ADDENDUM No. 1

Project: **Gear Replacement
FAMU – Ware-Rhanev**

Project Number: **2023-085**

Date: **April 30, 2024**

POWER RISER DIAGRAM
N.T.S.

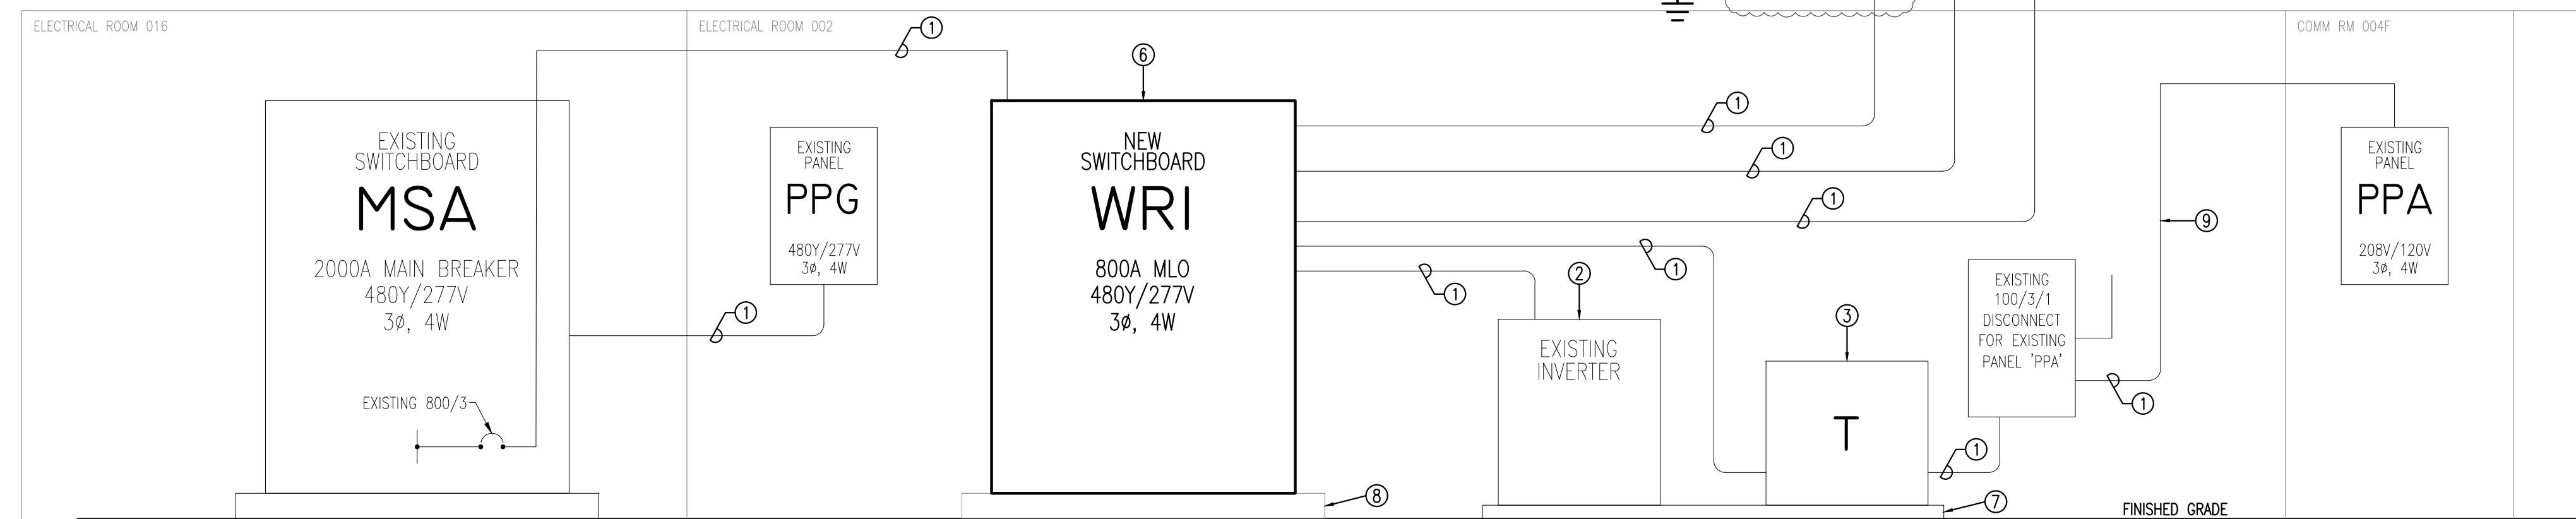
Item #D1: Sheet E-001 Electrical General, Notes, Legend, and Schedules:

1. Keynote #5 on 'Power Riser Diagram' modified to show the new padmount dry-type transformers to be 75 KVA in lieu of the original 45 KVA that was shown.
2. Note added to existing grounds for padmount transformers to confirm they are a minimum of #8 and to be replaced if required.
